RESUBMIT NO Approved
BY C. CARLSON DATE 04/22/15

CONTRACTORS VISPE	Rev	Date	By	Description	PRECAST CONCRETE APPROACH SLAB SHOP DRAWINGS (SDI JOB #15801)		INSTALLER:	FABRICATOR:
	1	04/16/15	IBA	Changes per State Review	SUPERVISOR: E. Barendse	PROJECT NAME: Walden BR# 030-3(5)	J.A. McDonald, Inc. PO Box 132 Lyndon Center, VT 05850	193 INDUSTRIAL AVE. WILLISTON, VT 05495 Ph: (802) 658-0201
					DETAILER: I. ADAMS	PROJECT #: 030-3(5)		
					CHECKER: E. Barendse	LOCATION: Walden, VT	04/08/2015	SLAB_BAR_2
					ENGINEER: VT AOT			8_OF_10

AS #3 Details

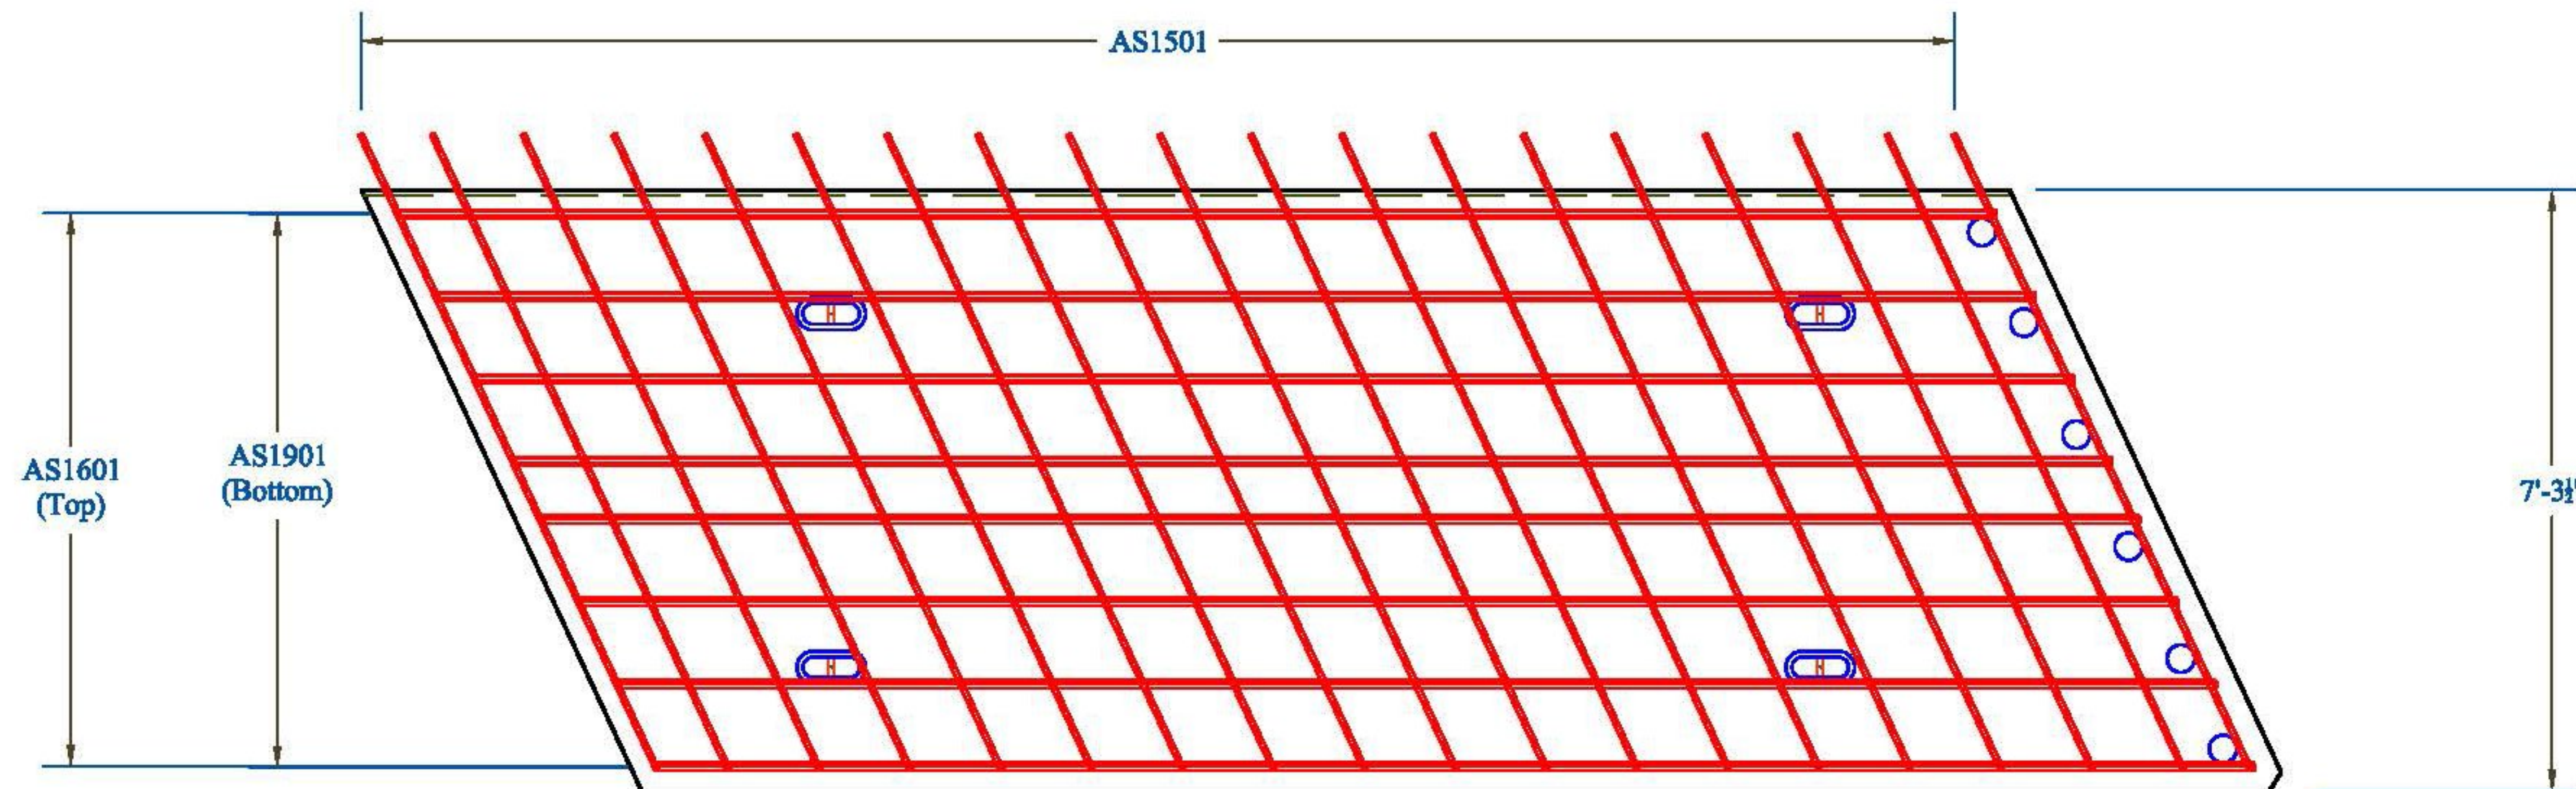
Check depth of lifting inserts to ensure they will not interfere with the rebar
